## ANSWERS TO CLARIFICATION QUESTIONS

File: AP\_3/1/13  
RFT: 2021/016  
Date: 15 March 2021  
To: Interested suppliers  
Contact: Maraea S. Pogi [maraeap@sprep.org](mailto:maraeap@sprep.org)  
Subject: Request for tenders: **Procurement, Supply, Installation and Commissioning of 80kWp Rooftop Solar System for the Pacific Climate Change Centre (PCCC) Building.**

Electrical Switchboard

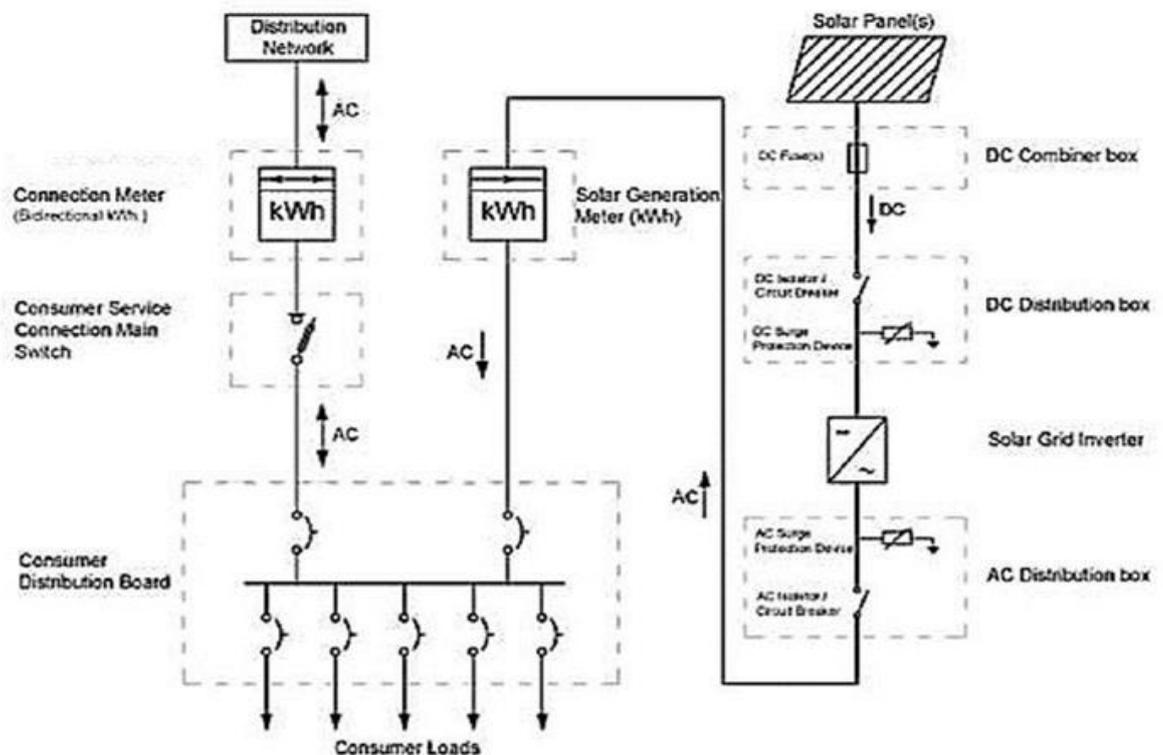
Capacity of the Electrical switchboard and configuration of circuits

Capable to connect three 20kW Inverters

System Voltage : 415V phase-phase

System Mains Rating : 300 -400 Amps

Max Protection Fuse for 20kW Inverter is 50Amps

Ensure cable used for the AC supply from inverters are sized and installed in accordance with AS/NZS3000, AS/NZS3008, AS/NZS 477.1 and EPC Grid Code 2020

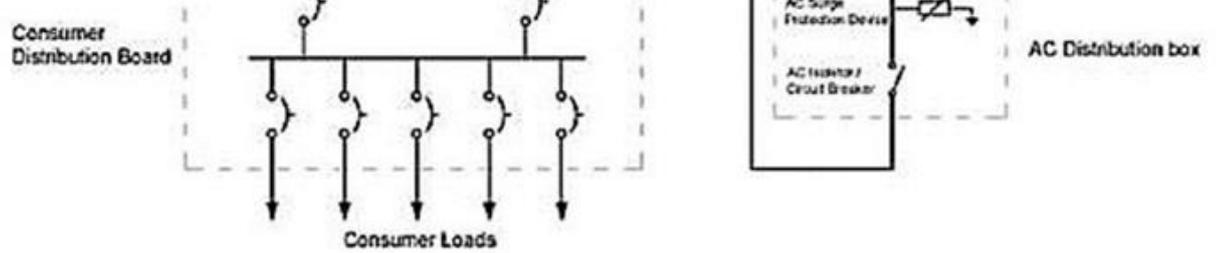
SMA inverters are expensive compared to other readily available units, they have known to fail due to heat and other conditions. The option is a different system, apart from the SMA, which could be installed next to the SMA, could this be an option to consider?

SMA has a good reputation throughout the Pacific region. Easy to get online assistance from Australia and NZ for technical issues. SPREP prefers to have similar Inverter(s) as the existing system, for easier access to spare parts, etc.
